# Access Compliance Report

## Public Rights-of-Way

### (Curb Ramps)

Intersection ID: 17739	Main Street: E_WOODLAWN_RD	Cross Street: SOUTH_BV	Location: NE
ADA ID: 9A0D3AFADEDD	Ramp Type: Perp	Initial Pass/Fail: Fail	Overall Compliance: No
Severity Score: 12.5			
Codes/Mitigation Info/Possible Solution		Field Measurements/Component Compliance

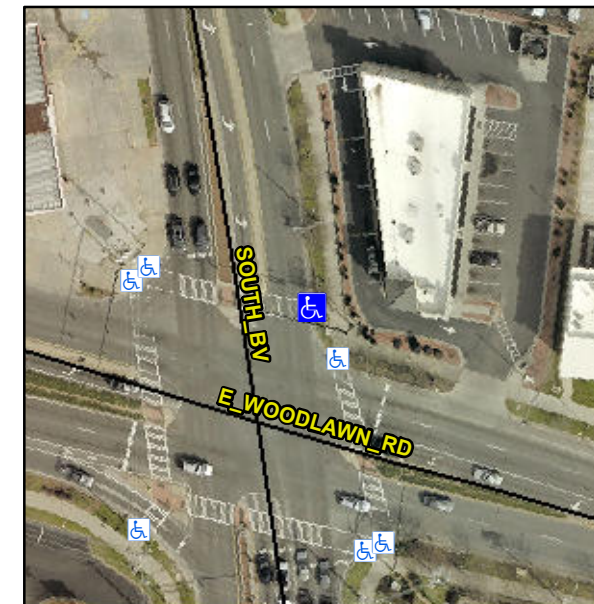
**Not Found, R304.2.2**

Compliance	Description	Data	Compliance	Description	Data
N/A	Ramp Length (in)	96.0	No	Ramp Slope (%)	11.6
Yes	Ramp Width (in)	48.0	Yes	Ramp XSlope (%)	1.5
N/A	Flare Type LT	N/A	N/A	Flare Type RT	N/A
N/A	Flare Slope LT (%)	N/A	N/A	Flare Slope RT (%)	N/A
N/A	Flare Traversable LT?	N/A	N/A	Flare Traversable RT?	N/A
N/A	Landing Length (in)	N/A	N/A	DWS Provided?	N/A
N/A	Landing Width (in)	N/A	N/A	DWS Contrast?	N/A
N/A	Landing Slope (%)	N/A	N/A	DWS Length (in)	N/A
N/A	Landing X Slope (%)	N/A	N/A	DWS Full Width?	N/A
N/A	Landing Curb? (Y/N)	N/A	N/A	DWS Offset (in)	N/A
N/A	Shared Landing?	N/A			
N/A	Gutter Ponding?	N/A	N/A	Gutter Slope (%)	N/A
N/A	Gutter Lip Ht (in)	N/A	N/A	Gutter X Slope (%)	N/A
N/A	Painted X Walk1?	Yes	N/A	Painted X Walk2?	N/A
	X Walk 1 Direction	To NW		X Walk 2 Direction	N/A
N/A	X Walk 1 Width (in)	120.0	N/A	X Walk 2 Width (in)	N/A
	X Walk 1 Slope (%)	1.9		X Walk 2 Slope (%)	N/A
	X Walk 1 X Slope (%)	1.2		X Walk 2 X Slope (%)	N/A

**Remove & Replace Entire Ramp.**
